FRIGG FIELD - DRILLING PLATFORM NO. 2
STRUCTURAL PARTS
DESIGN, FABRICATION AND INSTALLATION
(DFI) RESUMÉ

NORWEGIAN PETROLEUM DIRECTORATE

TECHNICAL REPORT

Date November 1, 1977	
Department 57	Project No. 601636
Approved by <i>S. H. Olsen</i>	
Client/Sponsor ref.	
Reporters sign. <i>Oddvar Alfstad</i>

These members are shown on Fig. 5.15.

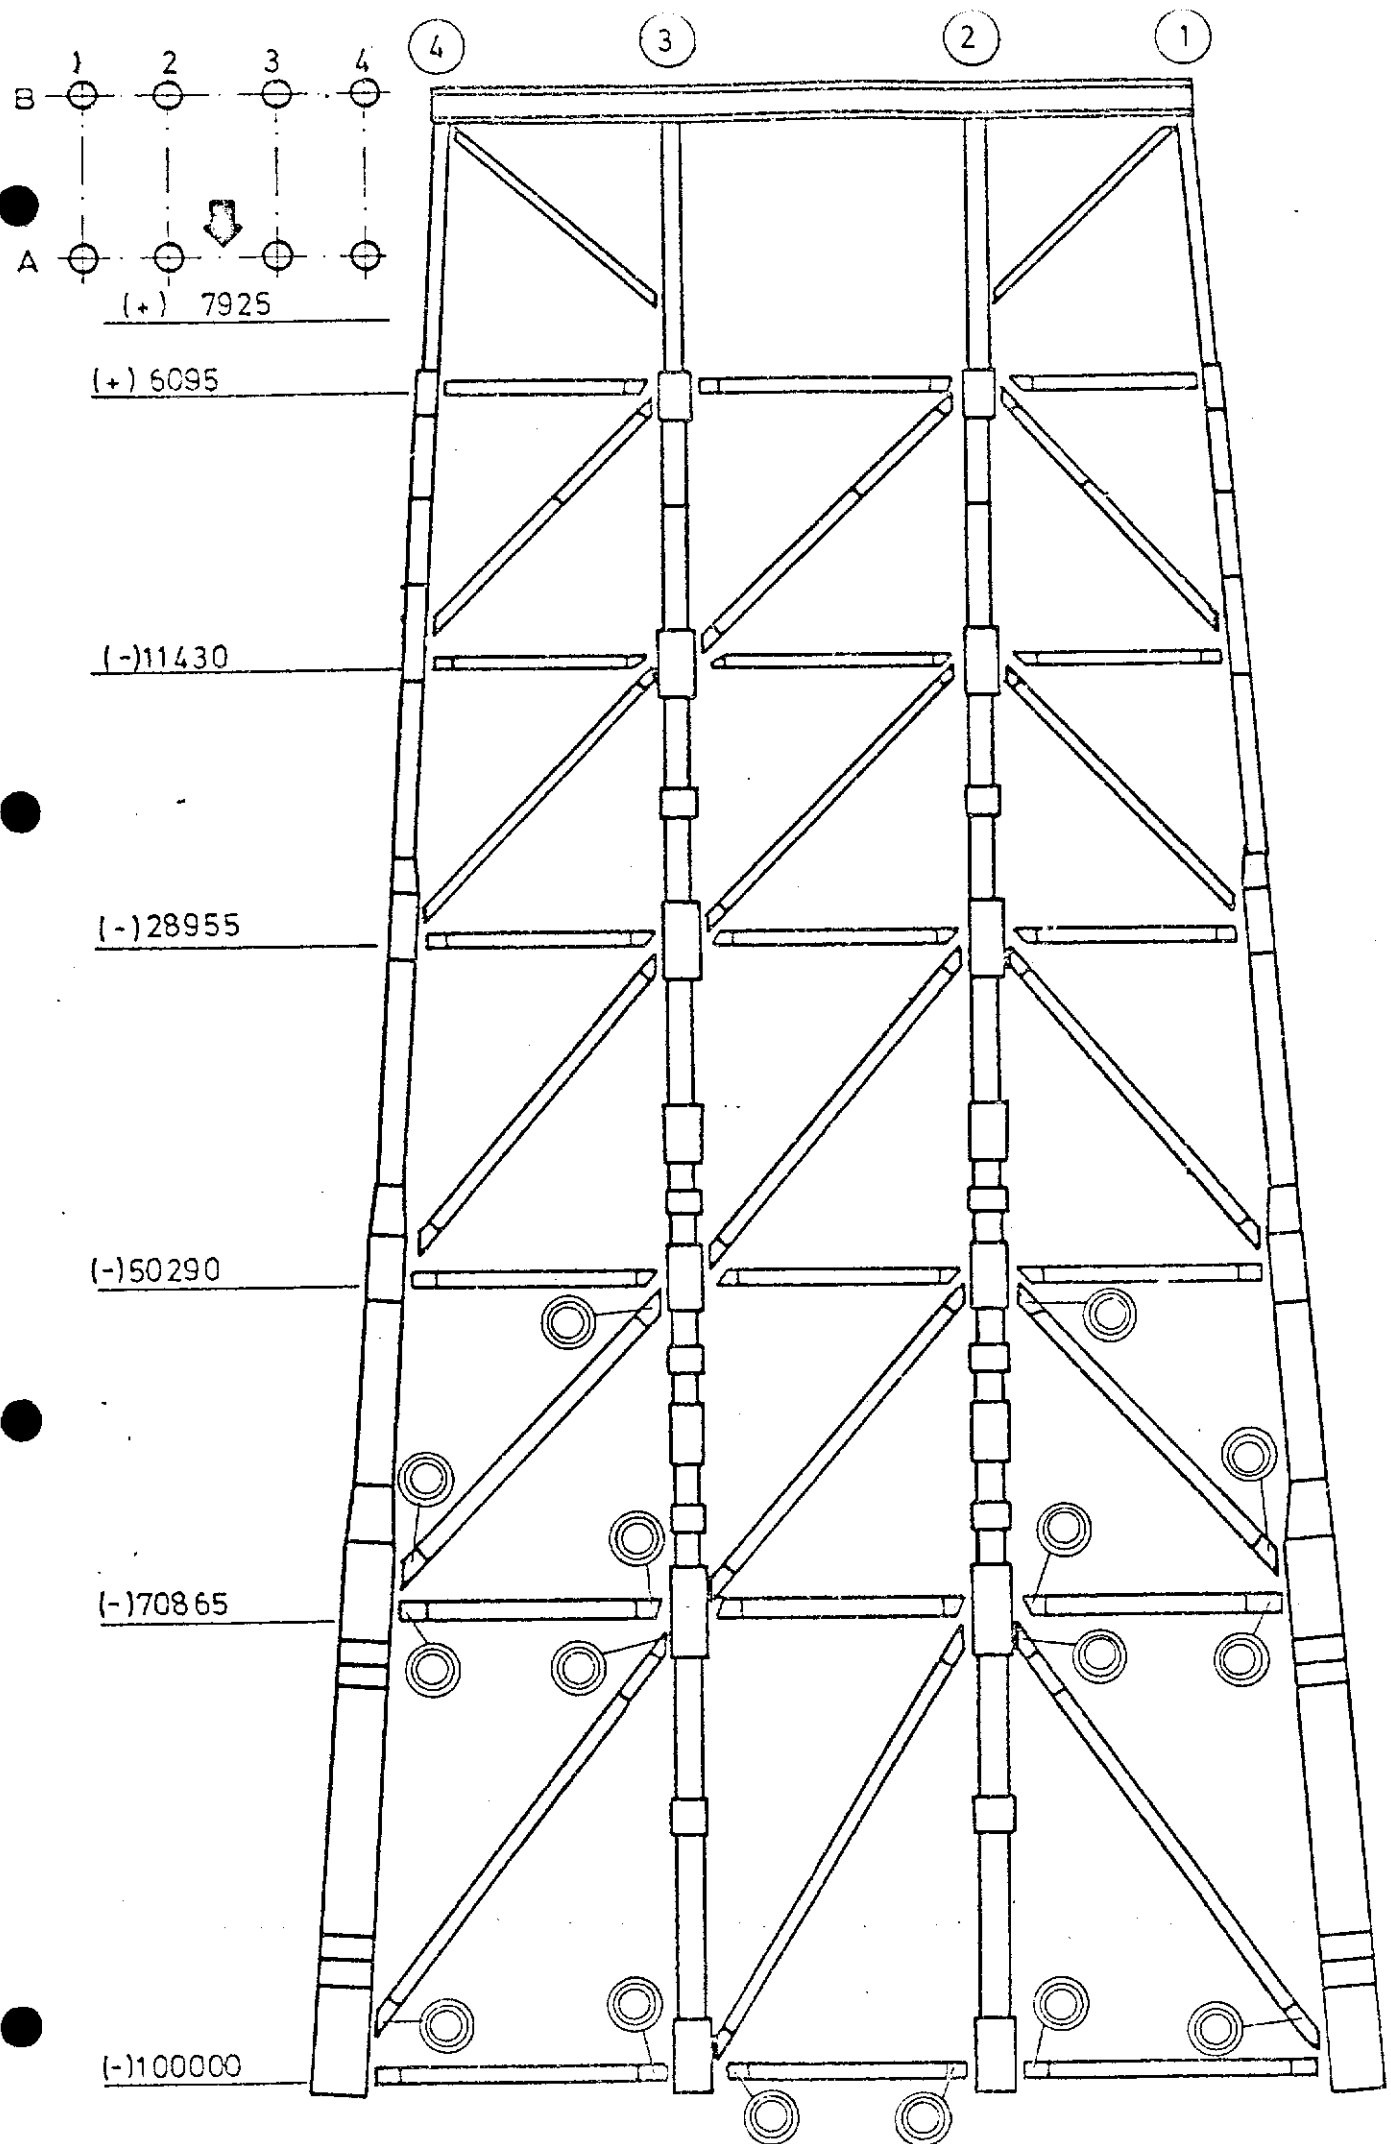
The production modules A, B, C and D are generally not very highly stressed.

However, some truss member in module D are marginally loaded.

Similar members on the remaining modules (A, B and C) should also be inspected regularly.
